# ACCESSIBILITY ASSESSMENT

*July 18, 2021*

## **ADA TITLE II ASSESSMENT**

Brinkley Hills  
6021 Thunder Hill Court  
Fort Washington, Maryland 20744

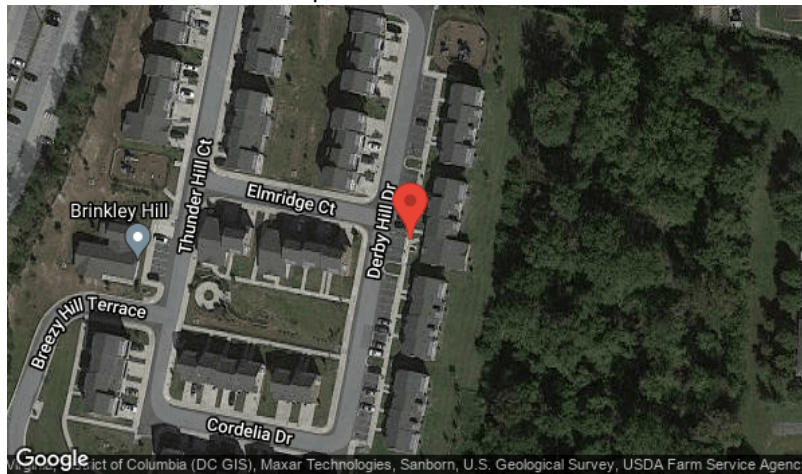
Assembly	Accessible Parking
Type	Parking Space-Van
ADA Standard	UFAS 4.6.3
Barrier Detail	The slope of the parking space is greater than 1:50 (2%).
Location Description	Accessible Parking Space P1
Observed	May 19, 2021 by Ouraccessibleworld@gmail.com
Site Conditions	The accessible space has slope of up to 5.9%.

Remove and replace with a van space that has no more than 1:50 (2%) slope in all directions. Parking spaces and access aisles shall be level with surface slopes not exceeding 1:50 (2%) in all directions. Parking access aisles shall be part of an accessible route to the building or facility entrance. Parked vehicle overhangs shall not reduce the clear width of an accessible circulation route. The quantity and order of magnitude cost estimate provided for this barrier are limited to the extent of the area identified as non-compliant. Additional costs that may be associated with removal of the barrier are not included.

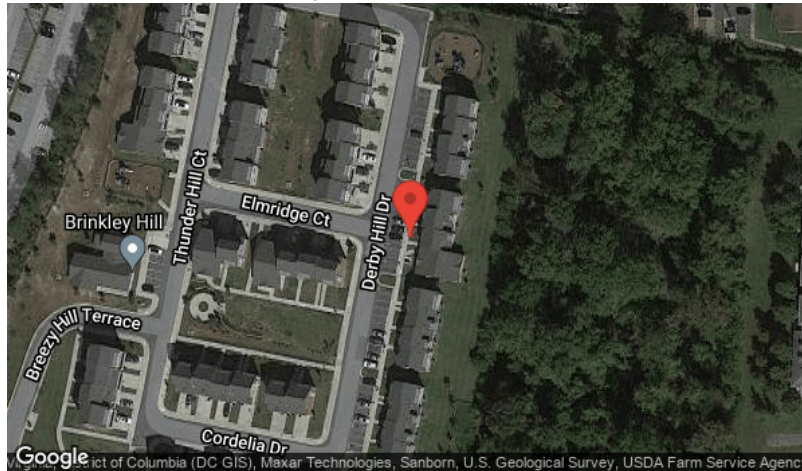
Assembly	Accessible Parking
Type	Parking Space-Car
ADA Standard	UFAS 4.6.3
Barrier Detail	The slope of the standard car parking space is greater than 1:50 (2%).
Location Description	Accessible Parking Space P2
Observed	May 18, 2021 by Ouraccessibleworld@gmail.com
Site Conditions	The accessible space has slopes of up to 2.8%.

Remove and replace with a parking space that has no more than 1:50 (2%) slope in all directions. Parking spaces for disabled people shall be at least 96" wide and shall have an adjacent access aisle 60" wide minimum (see Fig. 9). [EXCEPTION: If accessible parking spaces for vans are provided, each should have an adjacent access aisle at least 96" wide.] Parking access aisles shall be part of an accessible route to the building or facility entrance. Two accessible parking spaces may share a common access aisle. Parked vehicle overhangs shall not reduce the clear width of an accessible circulation route. Parking spaces and access aisles shall be level with surface slopes not exceeding 1:50 in all directions. The quantity and order of magnitude cost estimate provided for this barrier are limited to the extent of the area identified as non-compliant. Additional costs that may be associated with removal of the barrier are not included.

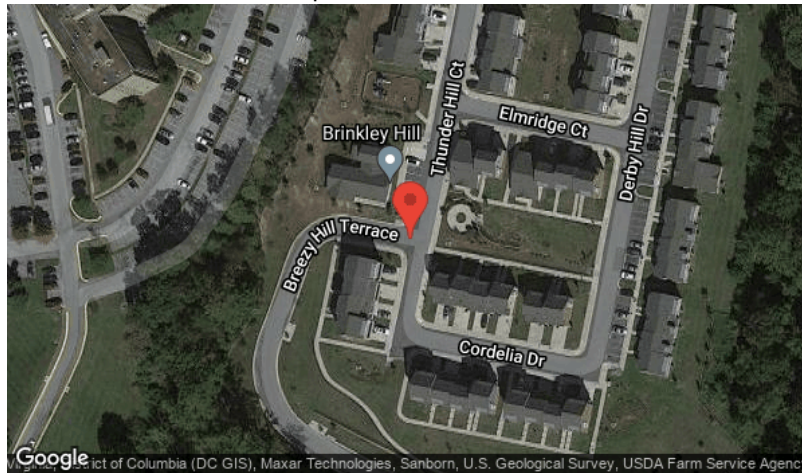
ADVISORY: A marked crosswalk is not provided where the accessible route crosses a vehicular way between the accessible parking aisle and the building entrance.

Location Description	Curb Ramp 2 to Curb Ramp3
Observed	May 19, 2021 by Ouraccessibleworld@gmail.com
Site Conditions	A marked access route at the street crossing is not provided.

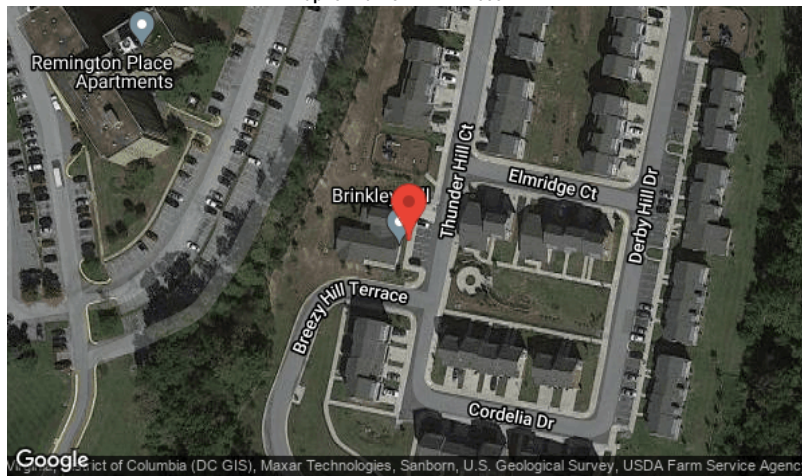
Assembly	Exterior Access Route
Type	Curb Ramp
ADA Standard	304, 406.4
Barrier Detail	The parallel curb ramp landing is not compliant.
Location Description	Curb Ramp CR1
Observed	May 18, 2021 by Ouraccessibleworld@gmail.com

The parallel curb ramp bottom landing has a slope of up to 2.3%. The top landing of the right ramp run has a slope of up to 2.4%.

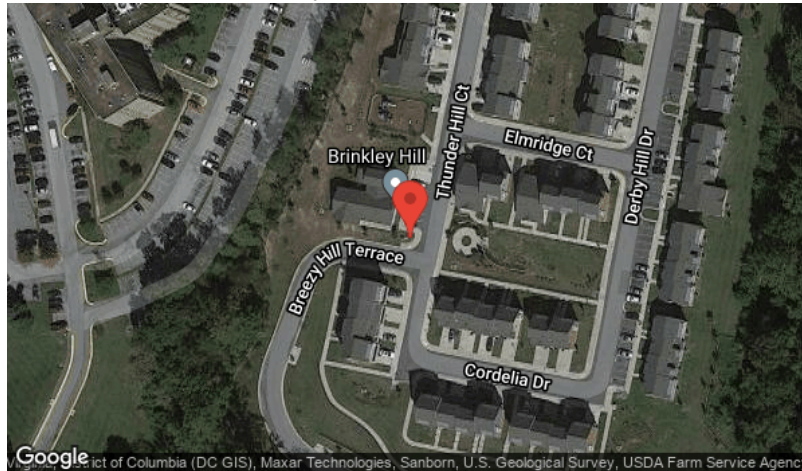
<b>Assembly</b>	Exterior Access Route
<b>Type</b>	Curb Ramp
<b>ADA Standard</b>	405.2; Table 405.2; 406; 406.2
<b>Barrier Detail</b>	The curb ramp does not meet the slope requirements.
<b>Location Description</b>	Curb Ramp CR2
<b>Observed</b>	May 18, 2021 by Ouraccessibleworld@gmail.com
<b>Site Conditions</b>	The curb ramp has a running slope of up to 17%.

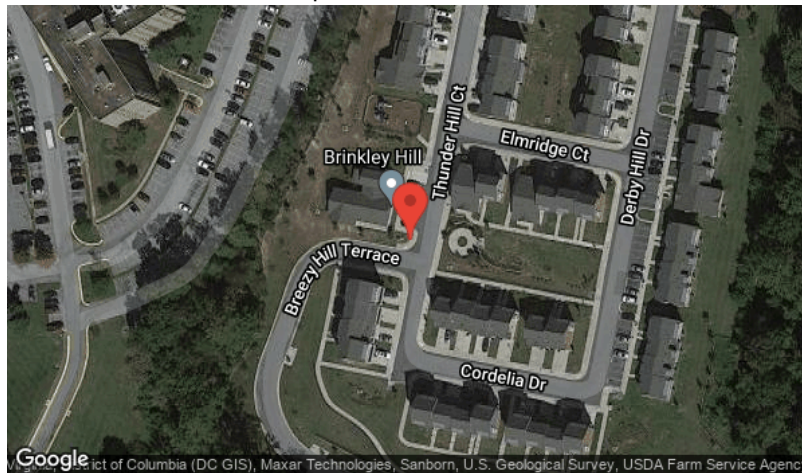
Assembly	Exterior Access Route
Type	Exterior Accessible Route
ADA Standard	403.3
Barrier Detail	The accessible route has cross slopes greater than 1:50 (2%).
Location Description	Curb Ramp CR2 to Office
Observed	May 18, 2021 by Ouraccessibleworld@gmail.com

The accessible route has a cross slope of up to 2.2% for a distance of approximately 15' by 5' wide.

The walkway should be graded to a maximum 1:50 (2%) cross slope. An accessible route has maximum 1:20 (5%) running slope and maximum 1:50 (2%) cross slope. [EXCEPTION: Cross slopes not exceeding 1:48 (2.08%) are permitted.] The clear width of walking surfaces shall be 36" minimum. [EXCEPTION: The clear width shall be permitted to be reduced to 32" minimum for a length of 24" maximum provided that reduced width segments are separated by segments that are 48" long minimum and 36" wide minimum.] Where grading to maximum running slope of 1:20 (5% running slope) is not possible, provide a compliant ramped surface within the walkway with maximum slope 1:12 (8.33%) and maximum ramp run rise of 6" without handrails. If a ramped surface with running slopes greater than 1:20 (5%) and maximum 1:12 (8.33%) rises more than 6", handrails are required. The cost estimate for this barrier removal is based on grading the running slope to maximum 1:20 (5%). The quantity and order of magnitude cost estimate provided for this barrier are limited to the extent of the area identified as non-compliant. Additional costs that may be associated with removal of the barrier are not included.

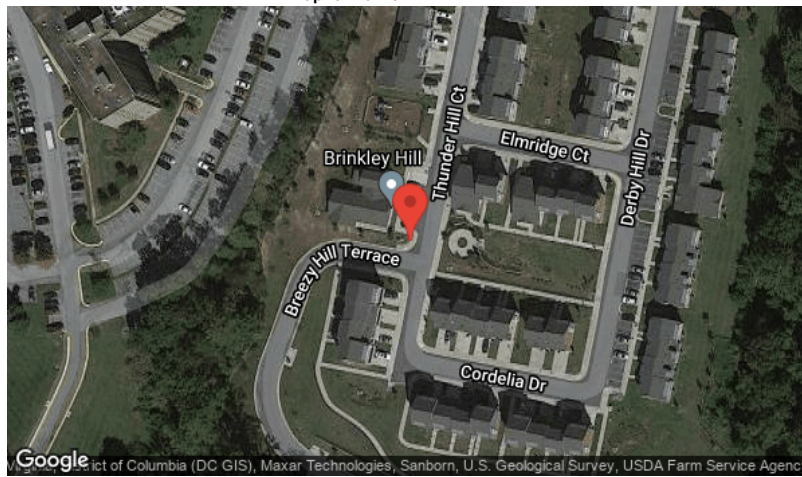
Assembly	Exterior Access Route
Type	Exterior Accessible Route
ADA Standard	304; 403.5.2
Barrier Detail	A compliant turning space is not provided at a change of direction.
Location Description	Curb Ramp CR2 to Office
Observed	May 18, 2021 by Ouraccessibleworld@gmail.com
Site Conditions	The turning space has a slope of 2.2%

Provide a compliant turning space at the change of direction. Floor or ground surfaces of a turning space shall be level. Changes in level are not permitted. [EXCEPTION: Slopes not steeper than 1:48 shall be permitted] [Advisory 304.2 Floor or Ground Surface Exception. As used in this section, the phrase "changes in level" refers to surfaces with slopes and to surfaces with abrupt rise exceeding 1/2" which are not ramped. Such changes in level are prohibited in required clear floor and ground spaces, turning spaces, and in similar spaces where people using wheelchairs and other mobility devices must park their mobility aids such as in wheelchair spaces, or maneuver to use elements such as at doors, fixtures, and telephones. The exception permits slopes not steeper than 1:48.] Turning space shall be either a circular space or a T-shaped space. The circular turning space shall be a space of 60" diameter minimum. The space shall be permitted to include knee and toe clearance. The T-shaped turning space shall be a T-shaped space within a 60 inch square minimum, with arms and base 36" wide minimum. Each arm of the T shall be clear of obstructions 12" minimum in each direction and the base shall be clear of obstructions 24" minimum. The space shall be permitted to include knee and toe clearance only at the end of either the base or one arm. Clear Width at 180 Degree Turn: Where the accessible route makes a 180 degree turn around an element which is less than 48" wide, clear width shall be 42" minimum approaching the turn, 48" minimum at the turn and 42" minimum leaving the turn. [EXCEPTION: Where the clear width at the 180 degree turn is 60" minimum, then the dimensional requirements for a 180 degree turn shall not be required.] The quantity and order of magnitude cost estimate provided for this barrier are limited to the extent of the area identified as non-compliant. Additional costs that may be associated with removal of the barrier are not included.

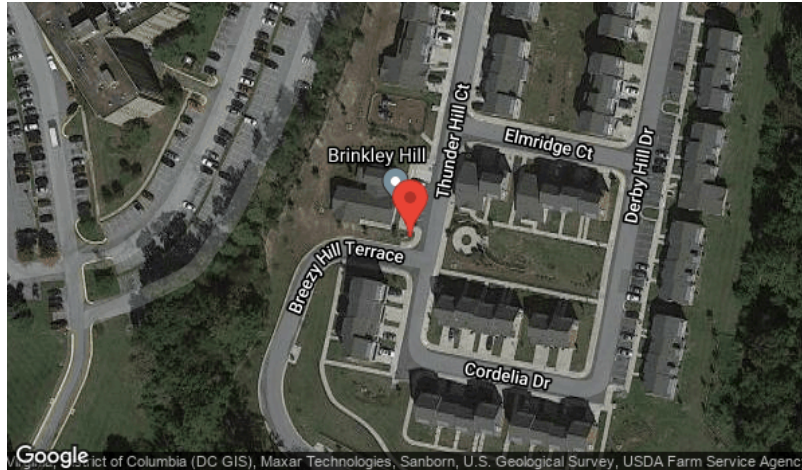
<b>Assembly</b>	Exterior Access Route
<b>Type</b>	Exterior Accessible Route
<b>ADA Standard</b>	403.3
<b>Barrier Detail</b>	The accessible route has cross slopes greater than 1:50 (2%).
<b>Location Description</b>	Curb Ramp CR3 to Leasing Office
<b>Observed</b>	May 18, 2021 by Ouraccessibleworld@gmail.com

The accessible route has a cross slope of up 2.8% for a distance of approximately 15 linear feet x 5'.

The walkway should be graded to a maximum 1:50 (2%) cross slope. An accessible route has maximum 1:20 (5%) running slope and maximum 1:50 (2%) cross slope. [EXCEPTION: Cross slopes not exceeding 1:48 (2.08%) are permitted.] The clear width of walking surfaces shall be 36" minimum. [EXCEPTION: The clear width shall be permitted to be reduced to 32" minimum for a length of 24" maximum provided that reduced width segments are separated by segments that are 48" long minimum and 36" wide minimum.] Where grading to maximum running slope of 1:20 (5% running slope) is not possible, provide a compliant ramped surface within the walkway with maximum slope 1:12 (8.33%) and maximum ramp run rise of 6" without handrails. If a ramped surface with running slopes greater than 1:20 (5%) and maximum 1:12 (8.33%) rises more than 6", handrails are required. The cost estimate for this barrier removal is based on grading the running slope to maximum 1:20 (5%). The quantity and order of magnitude cost estimate provided for this barrier are limited to the extent of the area identified as non-compliant. Additional costs that may be associated with removal of the barrier are not included.

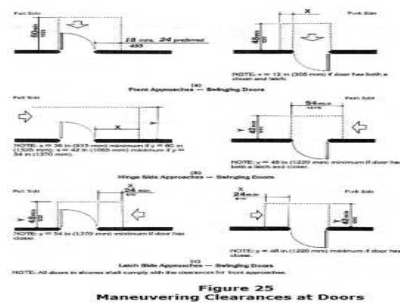
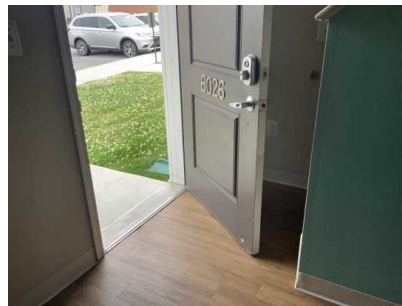
<b>Assembly</b>	Entrance to Building
<b>Type</b>	Building Entrance-Door
<b>ADA Standard</b>	UFAS 4.13.6; Fig. 25
<b>Barrier Detail</b>	The accessible door does not have the required maneuvering clearance.
<b>Location Description</b>	Door Clearance - Unit 6026, 6028 and 6030
<b>Observed</b>	May 19, 2021 by Ouraccessibleworld@gmail.com

For an approach from the latch side on the pull side the maneuvering depth is 41-1/2".

Replace with a compliant maneuvering clearance area that is level and clear. Minimum maneuvering clearances at doors that are not automatic or power-assisted shall be as shown in Figure 25. The required depth of the maneuvering clearance is 48" minimum. The required side clearance is 24" minimum on the latch side of the door. Maneuvering clearance shall extend the full width of the doorway and the required latch side clearance. The floor or ground area within the required clearances shall be level and clear. Entry doors to acute care hospital bedrooms for in-patients shall be exempted from the requirement for space at the latch side of the door (see dimension 'x' in Figure 25), if the door is at least 44" wide.

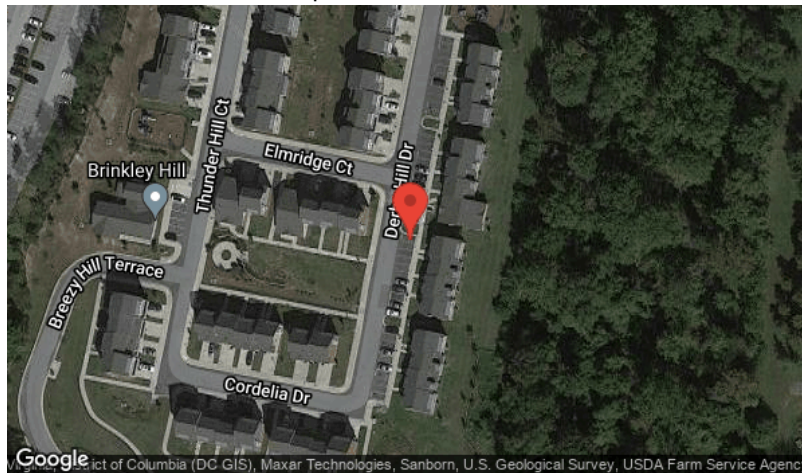
<b>Assembly</b>	Exterior Access Route
<b>Type</b>	Exterior Accessible Route
<b>ADA Standard</b>	403.3
<b>Barrier Detail</b>	The accessible route has running slopes greater than 1:20 (5%).
<b>Location Description</b>	From Accessible Parking to Units
<b>Observed</b>	May 18, 2021 by Ouraccessibleworld@gmail.com

The accessible route has a running slope of up to 6.8% for a distance of approximately 100 linear feet x 5'.

Grade the accessible route to maximum 1:20 (5%) running slope. An accessible route has maximum 1:20 (5%) running slope, maximum 1:50 (2%) cross slope, and minimum clear width 36". [EXCEPTION: Cross slopes not greater than 1:48 (2.08%) are permitted.] Where grading to maximum running slope of 1:20 (5% running slope) is not possible, provide a compliant ramped surface within the walkway with maximum slope 1:12 (8.33%) and maximum ramp run rise of 6" without handrails. If a ramped surface with running slopes greater than 1:20 (5%) and maximum 1:12 (8.33%) rises more than 6", handrails are required. A compliant ramp has maximum 1:12 (8.3%) running slope, maximum ramp run rise 30", landings at the top and bottom of ramp runs, handrails where the ramp run rise is greater than 6", and edge protection with exceptions. The cost estimate for this barrier removal is based on grading the running slope to maximum 1:20 (5%). The quantity and order of magnitude cost estimate provided for this barrier are limited to the extent of the area identified as non-compliant. Additional costs that may be associated with removal of the barrier are not included.

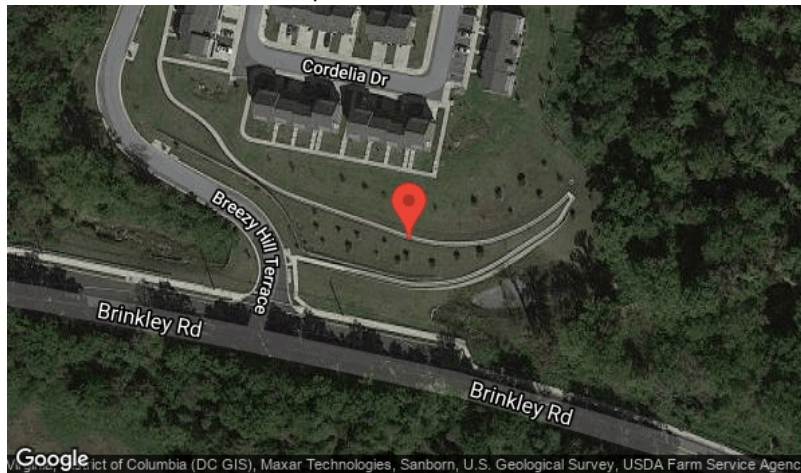
<b>Assembly</b>	Exterior Access Route
<b>Type</b>	Exterior Accessible Route
<b>ADA Standard</b>	403.3
<b>Barrier Detail</b>	The accessible route has cross slopes greater than 1:50 (2%).
<b>Location Description</b>	PROW From Street to Leasing Office - East Side
<b>Observed</b>	May 18, 2021 by Ouraccessibleworld@gmail.com

The accessible route has a cross slope of up to 3.4% for a distance of approximately 20 linear feet x 5'.

The walkway should be graded to a maximum 1:50 (2%) cross slope. An accessible route has maximum 1:20 (5%) running slope and maximum 1:50 (2%) cross slope. [EXCEPTION: Cross slopes not exceeding 1:48 (2.08%) are permitted.] The clear width of walking surfaces shall be 36" minimum. [EXCEPTION: The clear width shall be permitted to be reduced to 32" minimum for a length of 24" maximum provided that reduced width segments are separated by segments that are 48" long minimum and 36" wide minimum.] Where grading to maximum running slope of 1:20 (5% running slope) is not possible, provide a compliant ramped surface within the walkway with maximum slope 1:12 (8.33%) and maximum ramp run rise of 6" without handrails. If a ramped surface with running slopes greater than 1:20 (5%) and maximum 1:12 (8.33%) rises more than 6", handrails are required. The cost estimate for this barrier removal is based on grading the running slope to maximum 1:20 (5%). The quantity and order of magnitude cost estimate provided for this barrier are limited to the extent of the area identified as non-compliant. Additional costs that may be associated with removal of the barrier are not included.

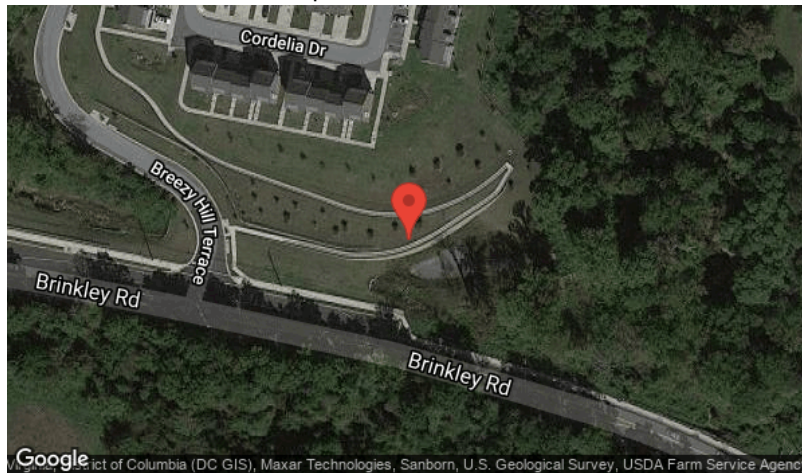
<b>Assembly</b>	Exterior Access Route
<b>Type</b>	Exterior Accessible Route
<b>ADA Standard</b>	403.3
<b>Barrier Detail</b>	The accessible route has cross slopes greater than 1:50 (2%).
<b>Location Description</b>	PROW From Street to Leasing Office - West Side
<b>Observed</b>	May 18, 2021 by Ouraccessibleworld@gmail.com

The accessible route has a cross slope of up to 2.9% for a distance of approximately 75' by 5' wide.

The walkway should be graded to a maximum 1:50 (2%) cross slope. An accessible route has maximum 1:20 (5%) running slope and maximum 1:50 (2%) cross slope. [EXCEPTION: Cross slopes not exceeding 1:48 (2.08%) are permitted.] The clear width of walking surfaces shall be 36" minimum. [EXCEPTION: The clear width shall be permitted to be reduced to 32" minimum for a length of 24" maximum provided that reduced width segments are separated by segments that are 48" long minimum and 36" wide minimum.] Where grading to maximum running slope of 1:20 (5% running slope) is not possible, provide a compliant ramped surface within the walkway with maximum slope 1:12 (8.33%) and maximum ramp run rise of 6" without handrails. If a ramped surface with running slopes greater than 1:20 (5%) and maximum 1:12 (8.33%) rises more than 6", handrails are required. The cost estimate for this barrier removal is based on grading the running slope to maximum 1:20 (5%). The quantity and order of magnitude cost estimate provided for this barrier are limited to the extent of the area identified as non-compliant. Additional costs that may be associated with removal of the barrier are not included.

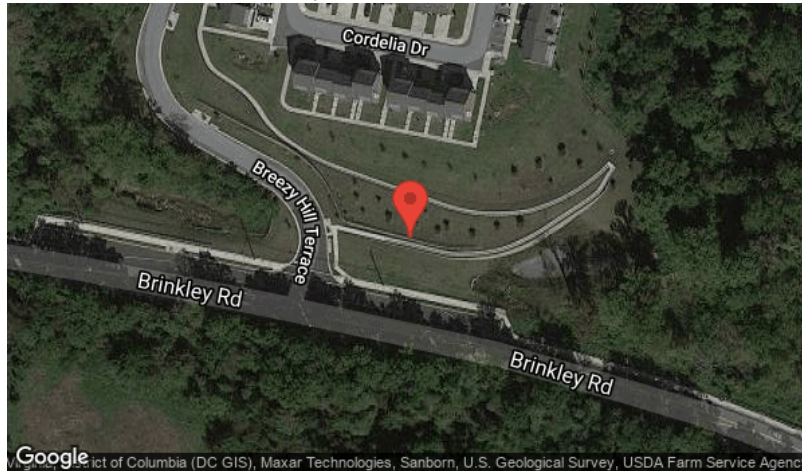
<b>Assembly</b>	Exterior Access Route
<b>Type</b>	Ramp
<b>ADA Standard</b>	405.8 and 505
<b>Barrier Detail</b>	The ramp run has a rise greater than 6"; however, handrails are not provided.
<b>Location Description</b>	Ramp R1
<b>Observed</b>	May 18, 2021 by Ouraccessibleworld@gmail.com

The ramp has two sections. The top section is 30' long with a running slope of up to 6.9%. The bottom section is 15' long with a running slope of up to 7.1%. Handrails are not provided at the ramp.

Provide compliant handrails or provide ramp runs with maximum 6" rise. Handrails are required on ramp runs which rise more than 6". Replace with continuous handrails at a consistent height above the ramp on both sides of the ramp. Inside handrails on switchback or dogleg stairs and ramps shall be continuous between runs. Top of gripping surfaces of handrails shall be 34" minimum and 38" maximum vertically above ramp surfaces. Handrails shall be at a consistent height above ramp surfaces. Clearance between handrail gripping surfaces and adjacent surfaces shall be 1-1/2" minimum. Handrail gripping surfaces shall be continuous along their length and shall not be obstructed along their tops or sides. The bottoms of handrail gripping surfaces shall not be obstructed for more than 20% of their length. Where provided, horizontal projections shall occur 1-1/2" minimum below the bottom of the handrail gripping surface. [EXCEPTIONS: 1. Where handrails are provided along walking surfaces with slopes not steeper than 1:20, the bottoms of handrail gripping surfaces shall be permitted to be obstructed along their entire length where they are integral to crash rails or bumper guards. 2. The distance between horizontal projections and the bottom of the gripping surface shall be permitted to be reduced by 1/8" for each 1/2" of additional handrail perimeter dimension that exceeds 4".] Handrail gripping surfaces with a circular cross section shall have an outside diameter of 1-1/4" minimum and 2" maximum. Handrail gripping surfaces with a non-circular cross section shall have a perimeter dimension of 4" minimum and 6-1/4" maximum, and a cross-section dimension of 2-1/4" maximum. Handrail gripping surfaces and any surfaces adjacent to them shall be free of sharp or abrasive elements and shall have rounded edges. Handrails shall not rotate within their fittings. Handrail gripping surfaces shall extend beyond and in the same direction of ramp runs. [EXCEPTIONS: 1. Extensions shall not be required for continuous handrails at the inside turn of switchback or dogleg ramps AND 3. In alterations, full extensions of handrails shall not be required where such extensions would be hazardous due to plan configuration.] Ramp handrails shall extend horizontally above the landing for 12" minimum beyond the top and bottom of ramp runs. Extensions shall return to a wall, guard, or the landing surface, or shall be continuous to the handrail of an adjacent ramp run.

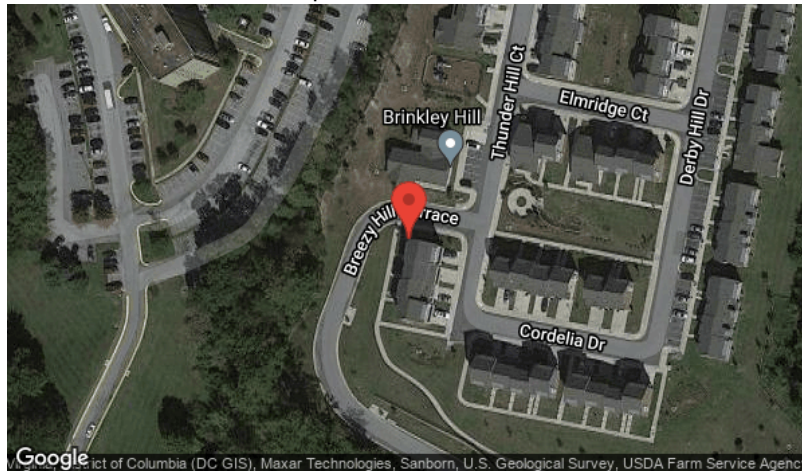
<b>Assembly</b>	Exterior Access Route
<b>Type</b>	Ramp
<b>ADA Standard</b>	405.8 and 505
<b>Barrier Detail</b>	The ramp run has a rise greater than 6"; however, handrails are not provided.
<b>Location Description</b>	Ramp R2
<b>Observed</b>	May 18, 2021 by Ouraccessibleworld@gmail.com

The accessible route has a cross slope of up to 3.6% and a running slopes from 7.5% to 11.4% for a distance of approximately 30 linear feet x 5'. Based on an average of the slopes a ramp with a rise of 34" with 1 intermediate landing is needed. The ramp will need handrails.

Provide compliant handrails or provide ramp runs with maximum 6" rise. Handrails are required on ramp runs which rise more than 6". Replace with continuous handrails at a consistent height above the ramp on both sides of the ramp. Inside handrails on switchback or dogleg stairs and ramps shall be continuous between runs. Top of gripping surfaces of handrails shall be 34" minimum and 38" maximum vertically above ramp surfaces. Handrails shall be at a consistent height above ramp surfaces. Clearance between handrail gripping surfaces and adjacent surfaces shall be 1-1/2" minimum. Handrail gripping surfaces shall be continuous along their length and shall not be obstructed along their tops or sides. The bottoms of handrail gripping surfaces shall not be obstructed for more than 20% of their length. Where provided, horizontal projections shall occur 1-1/2" minimum below the bottom of the handrail gripping surface. [EXCEPTIONS: 1. Where handrails are provided along walking surfaces with slopes not steeper than 1:20, the bottoms of handrail gripping surfaces shall be permitted to be obstructed along their entire length where they are integral to crash rails or bumper guards. 2. The distance between horizontal projections and the bottom of the gripping surface shall be permitted to be reduced by 1/8" for each 1/2" of additional handrail perimeter dimension that exceeds 4".] Handrail gripping surfaces with a circular cross section shall have an outside diameter of 1-1/4" minimum and 2" maximum. Handrail gripping surfaces with a non-circular cross section shall have a perimeter dimension of 4" minimum and 6-1/4" maximum, and a cross-section dimension of 2-1/4" maximum. Handrail gripping surfaces and any surfaces adjacent to them shall be free of sharp or abrasive elements and shall have rounded edges. Handrails shall not rotate within their fittings. Handrail gripping surfaces shall extend beyond and in the same direction of ramp runs. [EXCEPTIONS: 1. Extensions shall not be required for continuous handrails at the inside turn of switchback or dogleg ramps AND 3. In alterations, full extensions of handrails shall not be required where such extensions would be hazardous due to plan configuration.] Ramp handrails shall extend horizontally above the landing for 12" minimum beyond the top and bottom of ramp runs. Extensions shall return to a wall, guard, or the landing surface, or shall be continuous to the handrail of an adjacent ramp run.
